DOCUMENT 00 91 13

Addendum Number Two

PROJECT: ITD D5 Maintenance Building Addition and
Renovation and New Brine Facility
Blackfoot, Idaho

PROJECT NO.: 22569

1
P102 BRINE BUILDING PLUMBING PLAN
 SCALE: 1/4" = 1'-0"

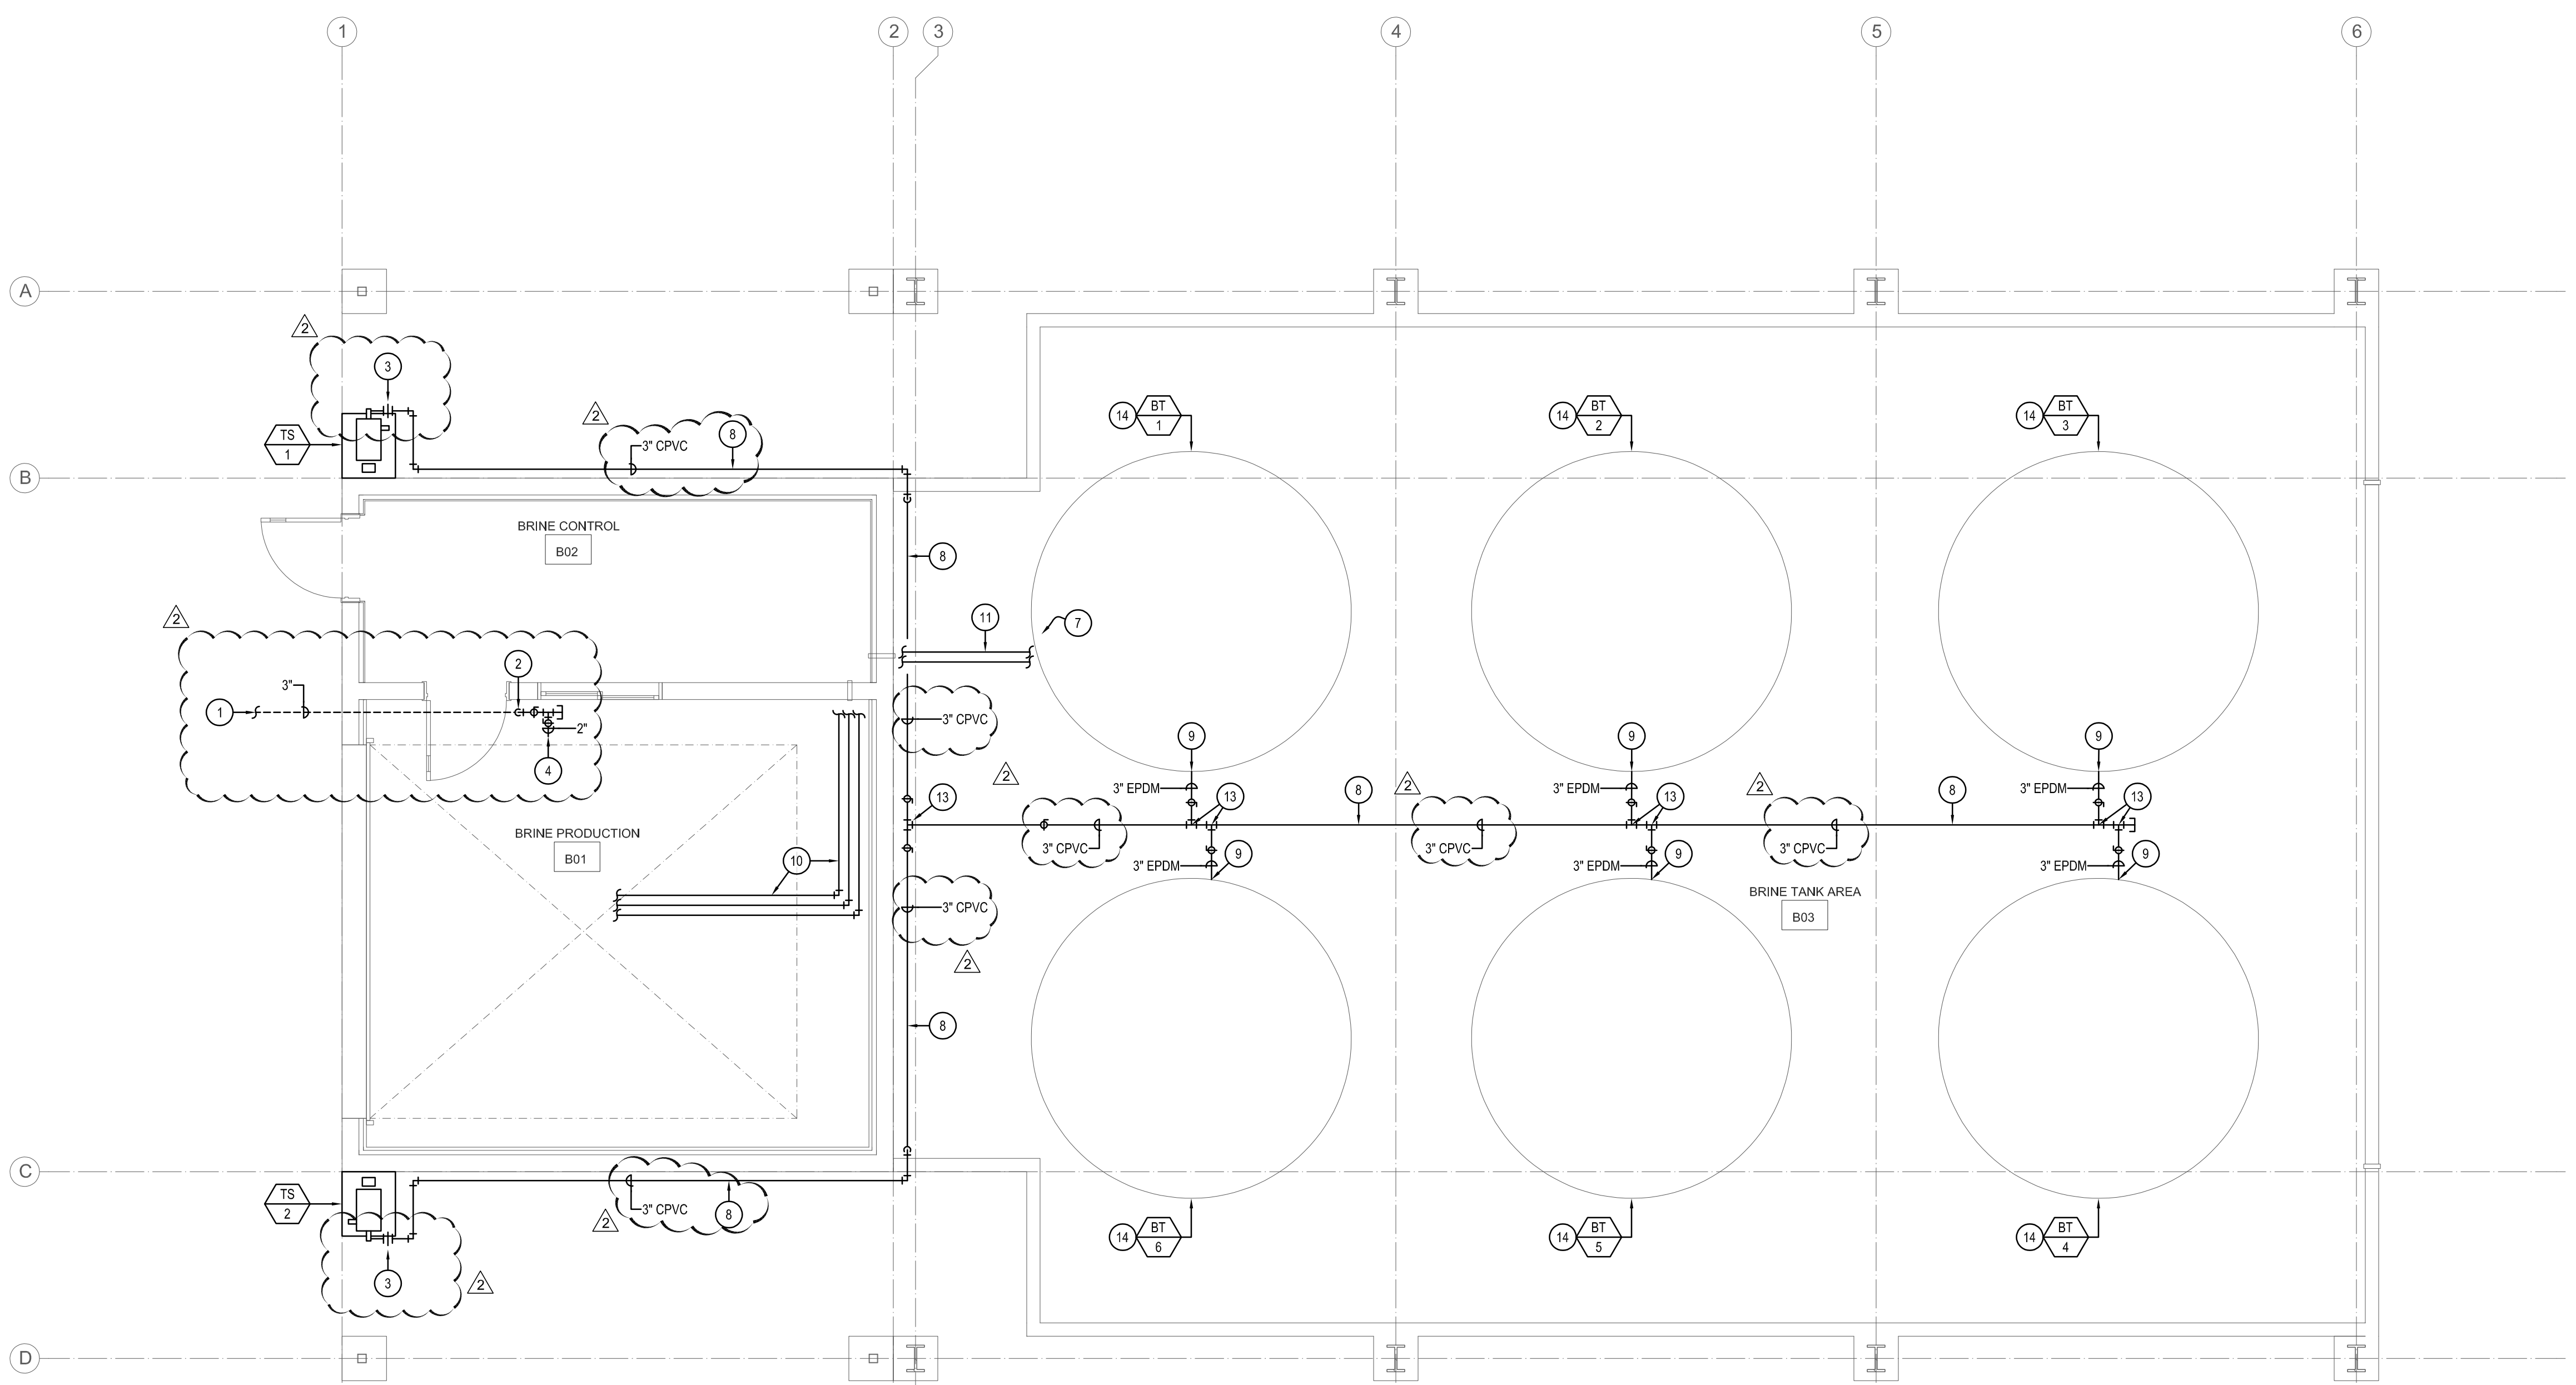
- c. Added Keynotes 8, 9, 10, & 11.
 - d. Removed
 - e. Updated sheet title.
4. Replace Sheet P102 – Brine Plumbing New Work Plan with attached Sheet P102 – Brine Plumbing New Work Plan. Revisions are as follows.

- d. Updated Keyed Note #2: ROUTE 3" NPCW UP FROM BELOW GRADE.
 - e. Updated Keynote #3: "PROVIDE TRANSITION AND REDUCER FROM 3" CPVC PIPE TO REINFORCED EPDM HOSE AT TRANSFER STATION PUMP (BASIS OF DESIGN: KANAFLEX 390SD).

- f. Updated Keynote #5: "NOT USED".
 - g. Updated Keynote #6: "NOT USED".
 - h. Updated Keynote #8: "ROUTE AND SUPPORT 3" CPVC PIPE PER DETAIL #3 ON SHEET P201.

- i. Updated Keynote #12: "NOT USED".
5. Replace Sheet P201 – Plumbing Details and Schedules with attached Sheet P201 – Plumbing Details. Revisions are as follows.

3 EXTERIOR PIPE SUPPORT DETAIL
NOT TO SCALE

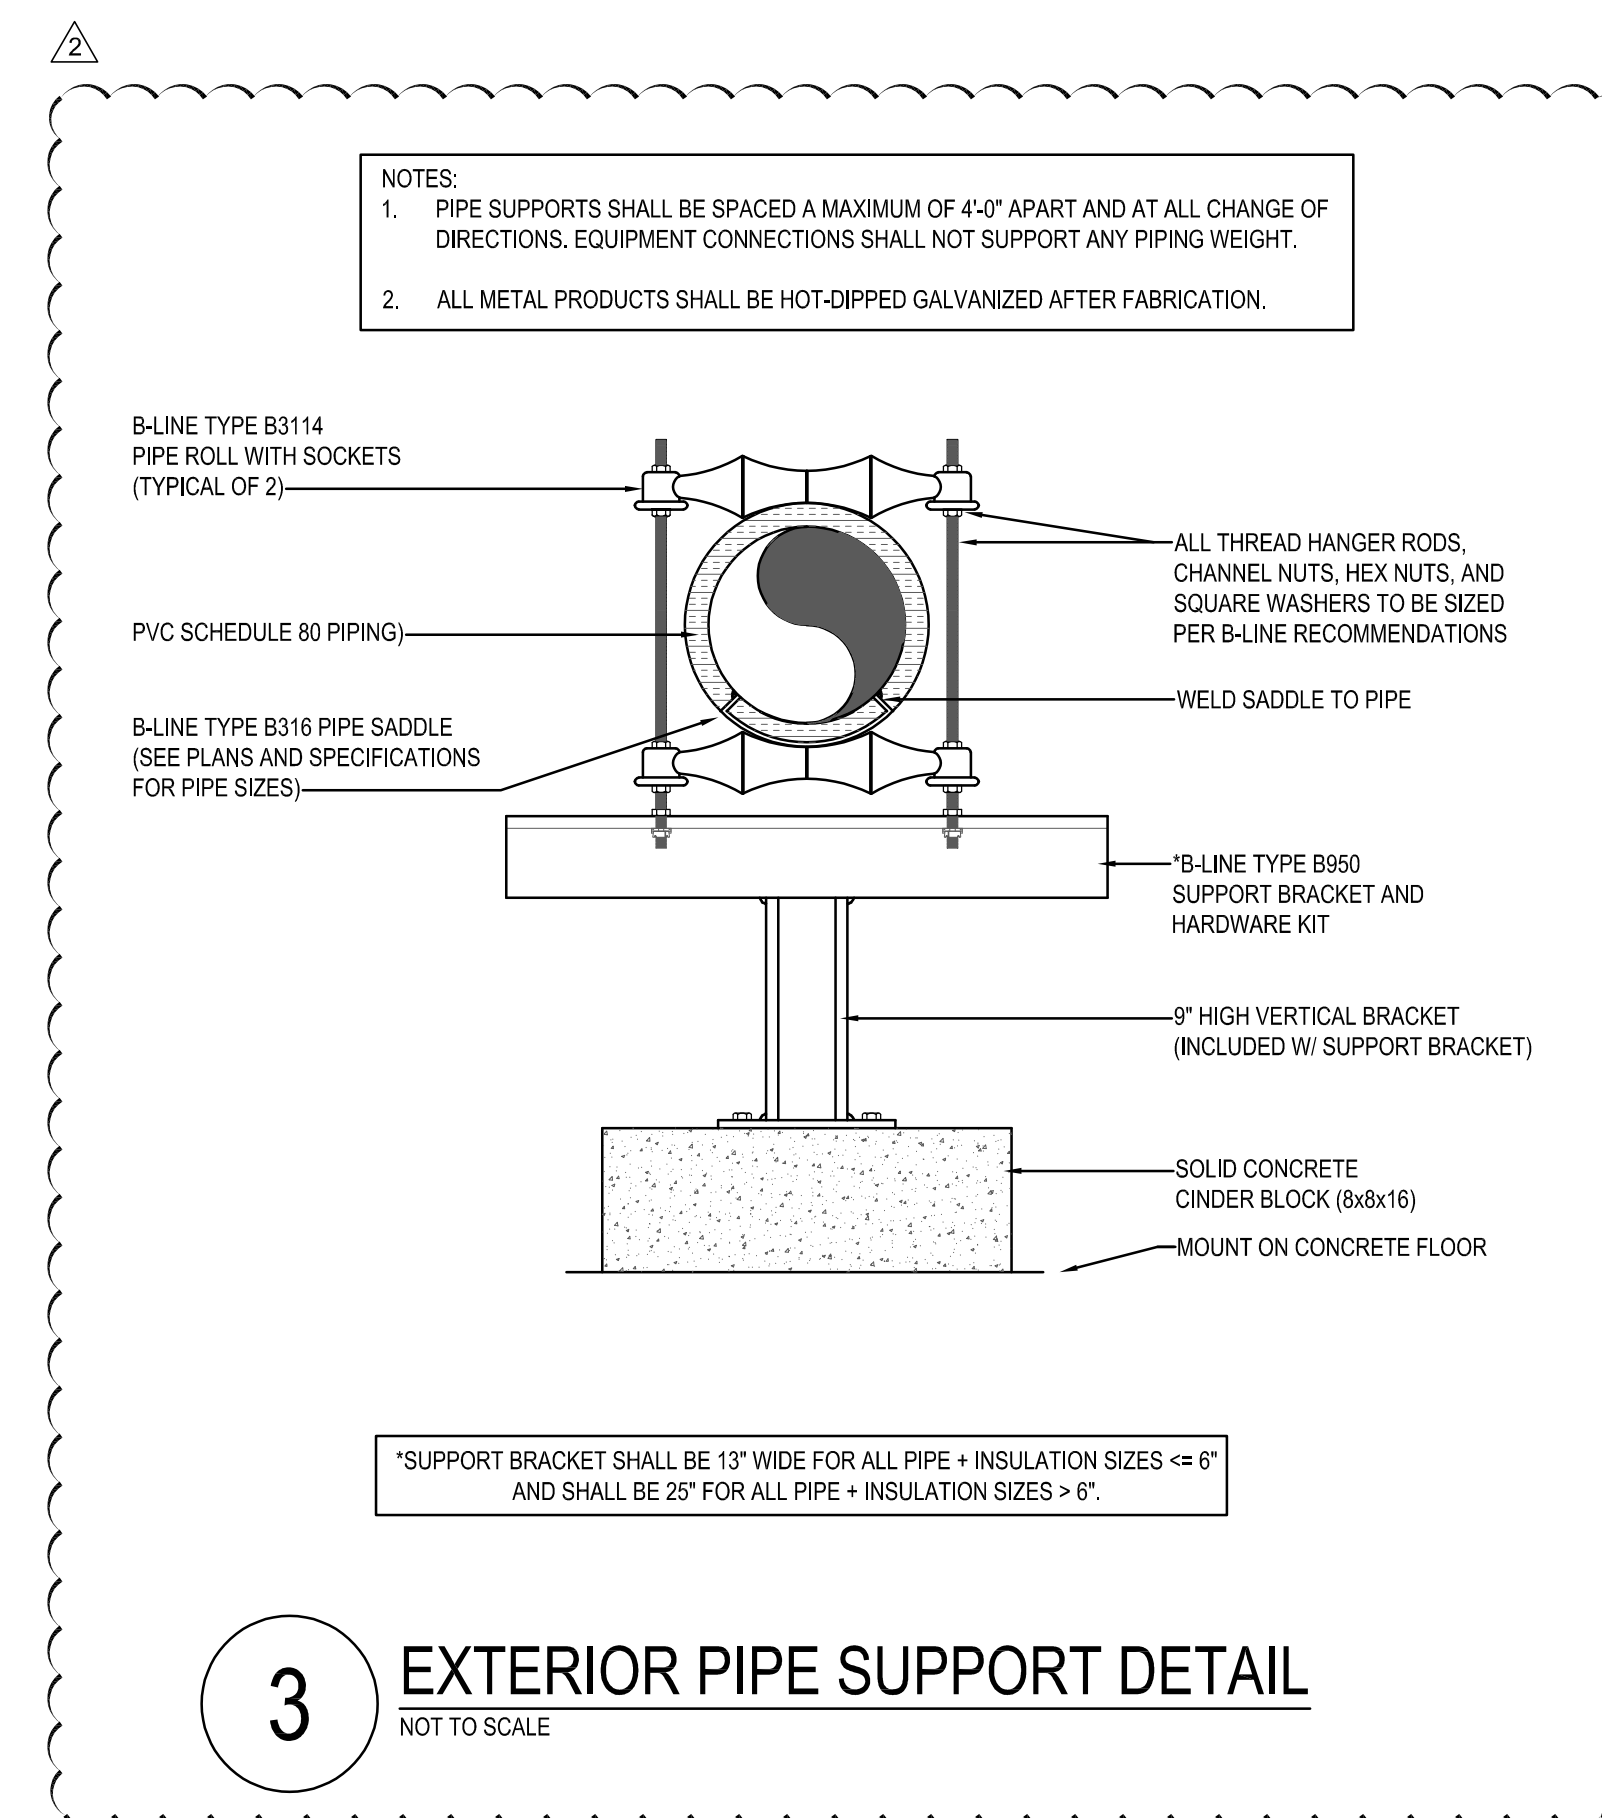
- a. Relocated schedules to Sheet P300.
 - b. Added Detail #3: Exterior Pipe Support Detail.
 - i. This detail applies to all PVC mains on brine system.
 - c. Updated sheet title.
